IN THE DRAWINGS

Please replace Figure 8 (8/13) of the application as filed with replacement Figure 8 (Replacement Sheet 8/13) herewith enclosed.

REMARKS

Fig. 8

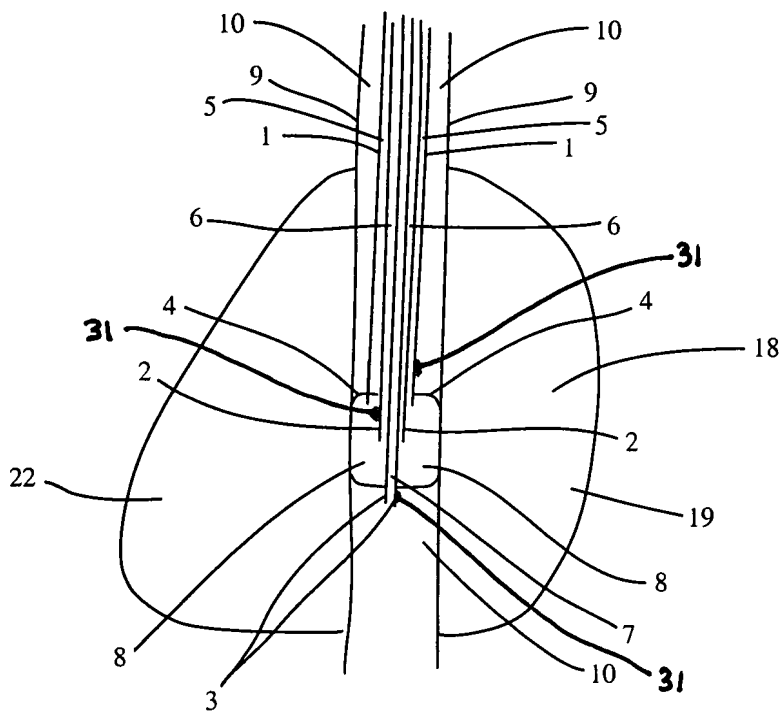
Applicants herewith submit new drawing, Figure 8, Sheet 8/13, labeled “Replacement Sheet” and a sheet showing changes labeled “Annotated Sheet” in compliance with 37 CFR § 1.121(d). Applicants have amended Figure 8 to include a marker, reference numeral 31. Support for the amendment of Figure 8 is to be found in the specification at page 13, paragraph 55, at page 18 paragraph 78, lines 4-7, at page 28, paragraph 112, lines 1-2 where the term “marker” is recited. No new matter is hereby entered with this amendment.

Applicants have amended the specification at page 18 to include element number 31 (“marker”) of the elements identified on Figure 8, as amended. No new matter is hereby entered with this amendment.
